HOWARD COUNTY HISTORIC PRESERVATION COMMISSION

2020 Minutes

February Minutes

Figure 5 - Proposed primary location

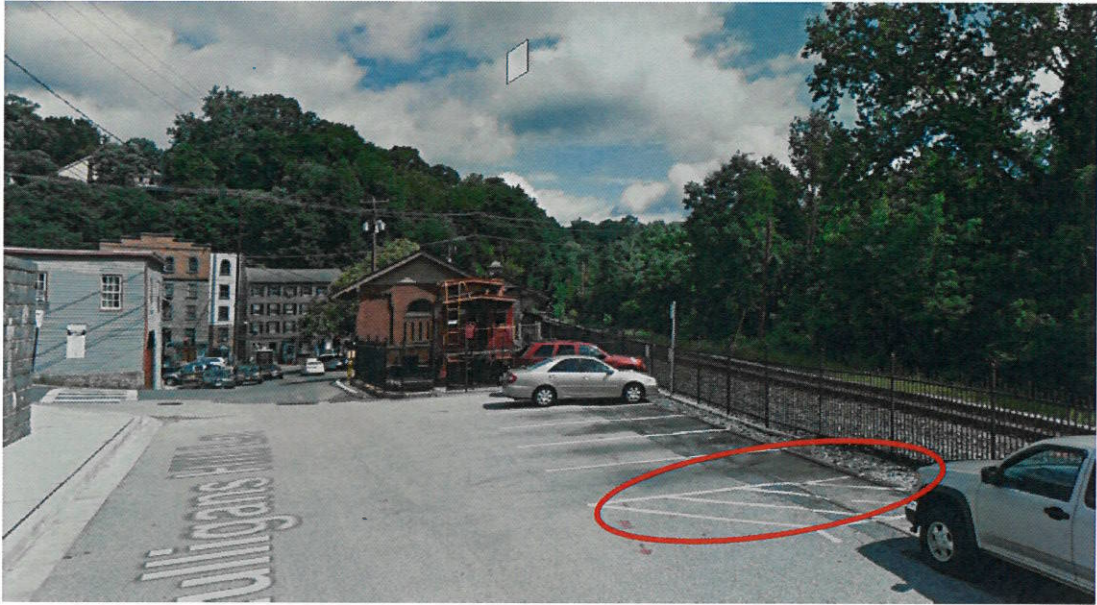
The proposed location for installation at 3711 Maryland Avenue/Parking Lot C is behind the train caboose, within Parking Lot C. This location is approximately 60 feet from the edge of the caboose. The alternate location (which depends on utilities, etc.) is at the parking spot directly behind the caboose, approximately 10 feet from the back of the caboose.

Figure 14 - Proposed scoring pattern

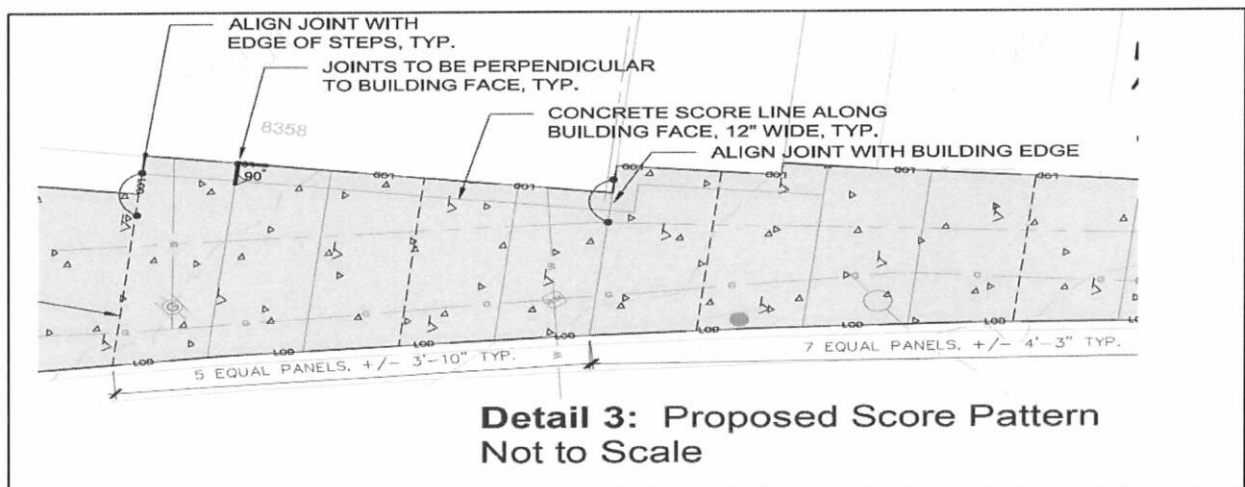
Over the course of these three meetings, the Commission had many questions on replacement sidewalks and expressed a desire to see brick sidewalks reinstalled in the future. The Commission seemed to generally agree that concrete was acceptable in places where sidewalks were largely destroyed in the floods, and as a result, are now mostly bituminous. In the areas where brick survived the floods and only had small areas of bituminous patchwork, the HPC found that brick should be used as the replacement material for the bituminous patch.

Figure 15 - Areas of proposed concrete replacement and brick repair

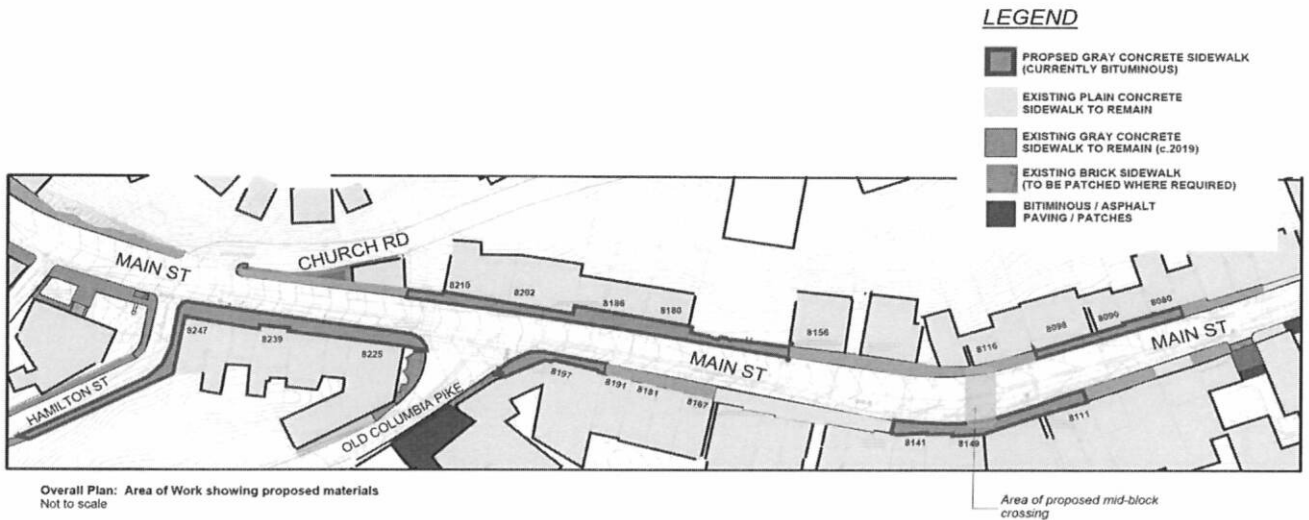
Scope of Work: The applicant proposes to replace the temporary bituminous sidewalks along Main Street, east of Church Road, with gray tinted concrete. In certain locations where the bricks did not entirely wash out, small patches of bituminous will be replaced with brick to match the existing. The application states, “concrete sidewalks are proposed at locations identified in the attached plan (Attachment C) and as shown in the attached photos (Attachment D). These include areas that are currently primarily bituminous paving. Where it is required for improved ADA compliance, small portions of existing brick sidewalks may be removed.”

Figure 1 - Corrected view of shed dormer to reflect siding instead of roofing shingles.

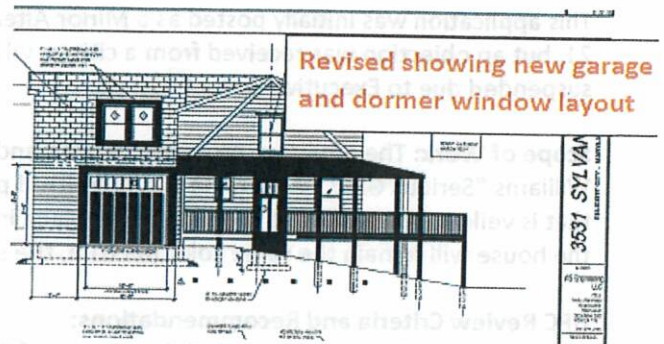
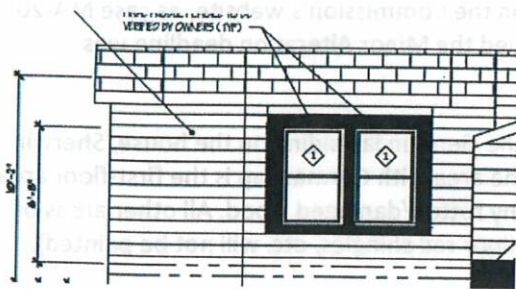
The elevation incorrectly shows roofing shingles on the revised shed dormer, instead of siding. The applicant noted that was to remain siding and not become roofing shingles and submitted an edited view of this elevation to correctly show siding.

Figure 6 - Existing garage

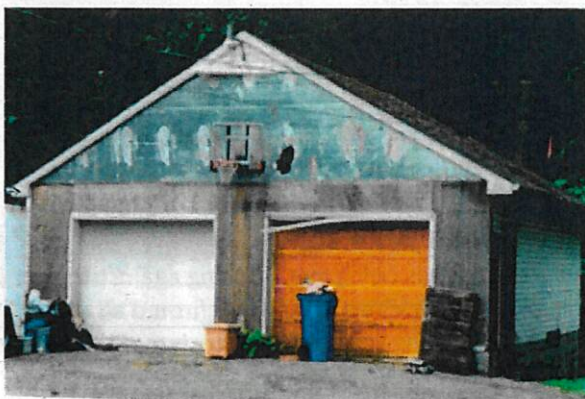
Ms. Zoren said in Figure 6 of the staff report, there was an existing garage with a basketball hoop, and noted the siding on the garage in Figure 6 did not have vinyl siding. Ms. Zoren asked if Mr. Engebretsen was proposing to add vertical wood siding on that garage as well.

Figure 20 - Historic house in the Tudor Revival style at 3958 Old Columbia Pike

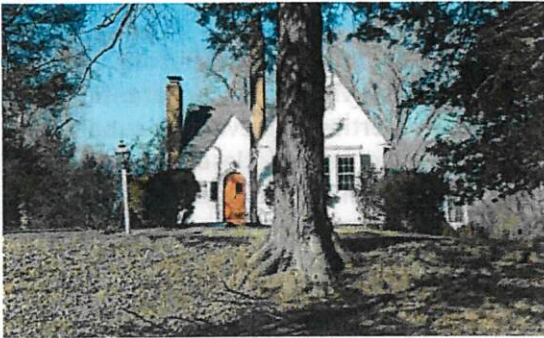
The new homes are shown in a “modern craftsman style,” which is not compatible with the existing historic house at 3958 Old Columbia Pike. The house at 3958 was constructed in the Tudor Revival style. The examples provided of the new homes will be significantly larger than the existing historic house, share no similar architectural features, and impact the viewshed and setting of the historic structures.

Figure 16 - Proposed rear alterations

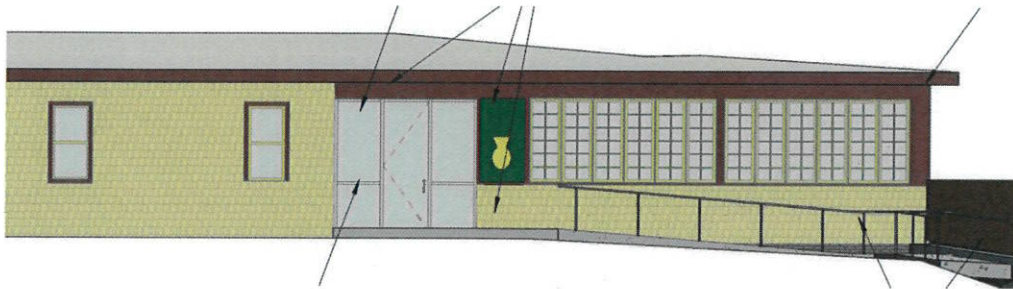
Ms. Zoren agreed with Mr. Reich's suggestion about the motif being a separate submittal as the motif seems almost like additional signage advertising the function of the building. Ms. Zoren said the architecture was very interesting as it has a chamfered corner, but the corner does not look at anything. Ms. Zoren noted in figure 15 is a perfect place for the chamfered corner, the hill of Old Columbia Pike would allow for more of a view on that side. Ms. Zoren asked if the Applicant was thinking of following her suggestion. Mr. Alexander said it was not the number one reason for his design, but the owners are close enough to the property line that there can be no window on that side of the building. Mr. Alexander wants the building to be seen. When one walks up Main Street the building is obliquely seen, which is the view one would have. The proposed addition wraps around the primary kiln and allows it to be visible, which is why the addition faces the direction it does. Ms. Zoren asked if Mr. Alexander was

Figure 15 - Comparison of proposed veneer against existing brick.

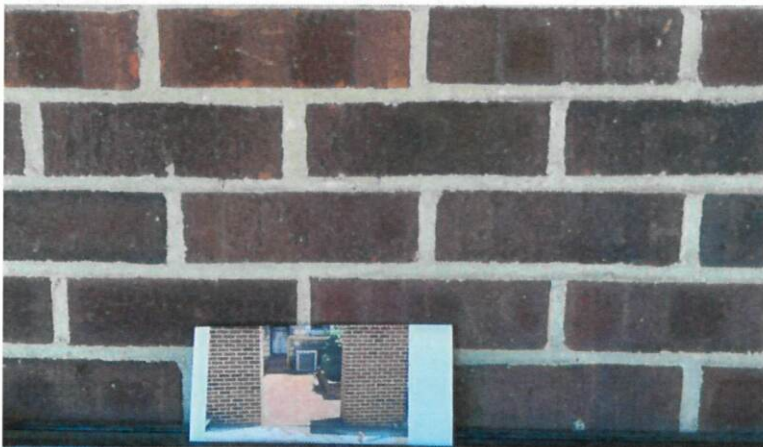
Mr. Roth said he was fine with the material submitted as the wall faces the building and would not otherwise be visible. He said the process of rebuilding the wall, moving it and using the veneer was fine. Mr. Roth said the Commission was also supposed to approve the styles of the tables and chairs shown in Figure 12 of the agenda. Mr. Roth pointed out the third option on the right and said the chairs look like white plastic chairs that are stackable and found the style was not appropriate.

Figure 20 - Site Plan showing proposed planting. Larger, clear version found in application packet.

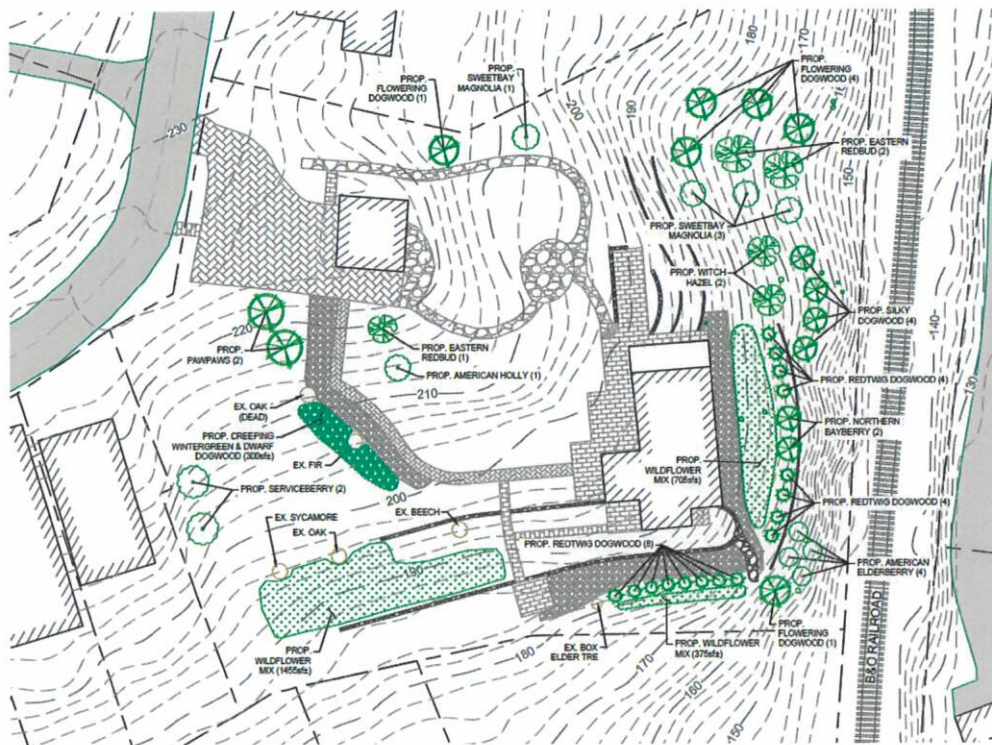
Mr. Roth and Mr. Taylor discussed the Commission's role with reviewing replacement trees in a historic setting. Mr. Roth said the proposed plantings seem to be appropriate within the Guidelines as they are native trees and would complement the historic setting and based on locations of where the previous trees where as shown on sheet C-1 of the application tree removal schedule labeled T1-T12, the trees were very close to the house or on a steep slope in close proximity to the railroad tracks it may have been appropriate to remove them.

Figure 8 - Historic American Buildings Survey Detail, vignette from 'View of Ellicotts Mills from the Heights above Elizabeth Ellicott's Residence' Lithograph, E. Sachse & Co.,

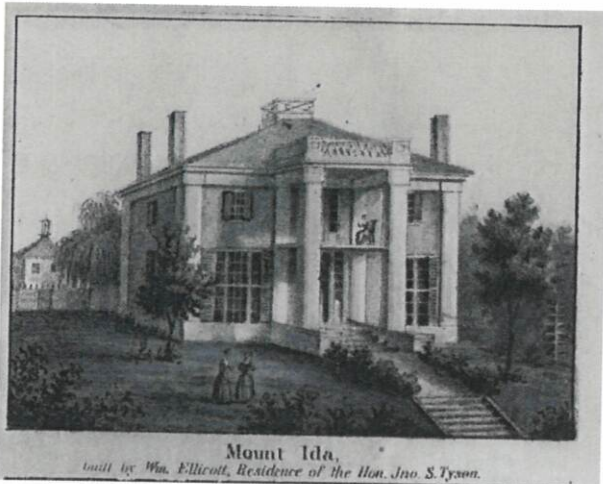
The building has been without railings for much of its life, and the design of the original railings is unknown. Figure 8, below, shows an 1854 lithograph view of the building. While the artist rendering in Figure 8 shows the building without a railing, it most likely had one for safety reasons. Safety is also the reason for the request to add railings now. Chapter 6.F states that "altering a porch can dramatically alter the appearance of a building" and recommends that if a porch must be replaced, "even if simplified in detail, should reflect the visual weight of the original." The original design is unknown so a simplified design, minimal in bulk and visual appearance, such as a white wood picket, would retain the character and avoid altering the appearance of the building.
